From: [Wilson Frazier](#)
To: [Lockett, Jay P](#)
Subject: 8000 Broad Run Rd. Case # 22-MSUB-0001
Date: Wednesday, March 30, 2022 10:54:03 AM

PETITION RE: 8000 BROAD RUN ROAD, LOUISVILLE, KENTUCKY Case #22-MSUB-0001

The proposal is for a **PRELIMINARY SUBDIVISION** and Mixed Residential Development Incentive (MRDI) Plan, Floyds Fork Development Review Overlay, a review of land disturbing activities on steep slopes and waivers.

Figure 2-26. Median Driver Reaction Time to Expected and Unexpected Information

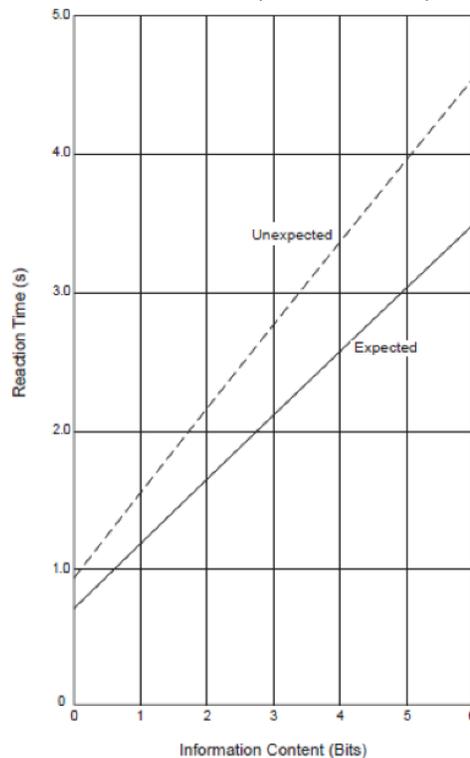
According to the AASHTO Green Book, "Information takes time to process. Drivers' reaction times increase as a function of decision complexity and the amount of information to be processed. Furthermore, the longer the reaction time, the greater the chance for error. Johansson and Rumar (27) measured brake reaction time for expected and unexpected events. Their results show that when an event is expected, reaction time averages about 0.6 s, with a few drivers taking as long as 2 s. With unexpected events, reaction times increased by 35 percent. Thus, for a simple, unexpected decision and action, some drivers may take as long as 2.7 s to respond. A complex decision with several alternatives may take several seconds longer than a simple decision. Figure 2-26 [above] shows this relationship for median-case drivers."

Figure 1. CMF for lane width on rural two-lane roadway segments (12).

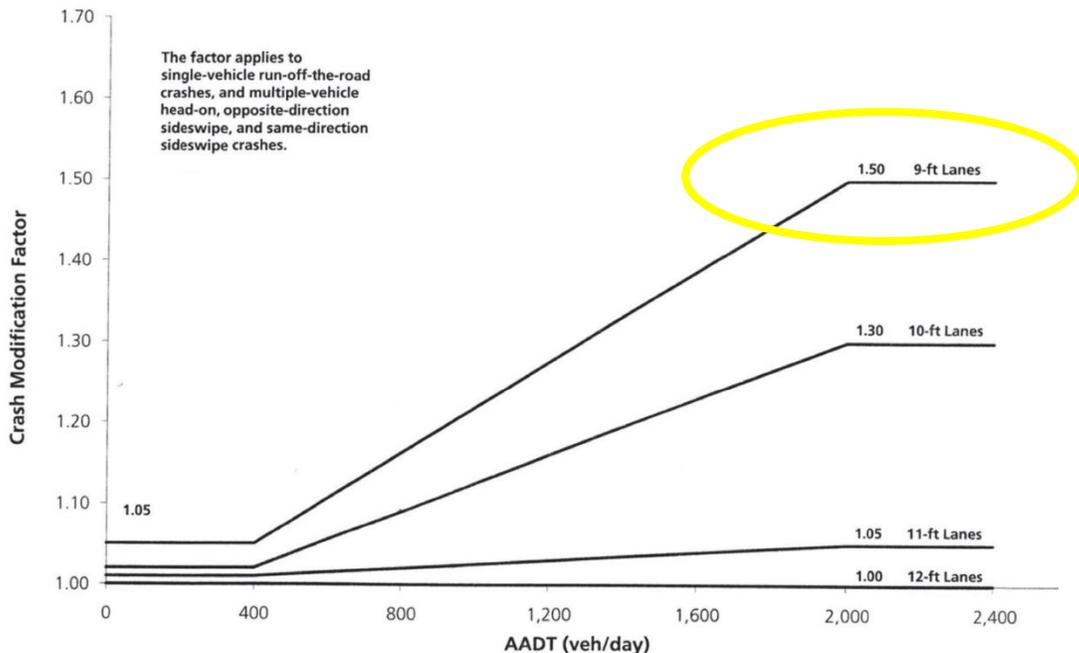
The question is not whether Broad Run Rd. can handle additional “peak time capacity” that only evaluates flow. The critical question is about performance. Will Broad Run Rd. safely handle the additional Average Daily Traffic? In 2018, Broad Run Rd. vehicle count was up to 1000 vehicles per day. With regards to lane width, increasing Broad Run Rd. average daily traffic from the design of <400 vehicles per day to >2,000 vehicles per day, with all of the safety variables discussed above, will increase the crash modification factor (CMF) from 1.05 to 1.5 (Table 6). And concerning shoulder width, assuming the same traffic increases, and ZERO shoulder width, the CMF will increase from 1.10 to a factor of 1.5.

See Table 6, Figure 1, Table 13, and Figure 4.
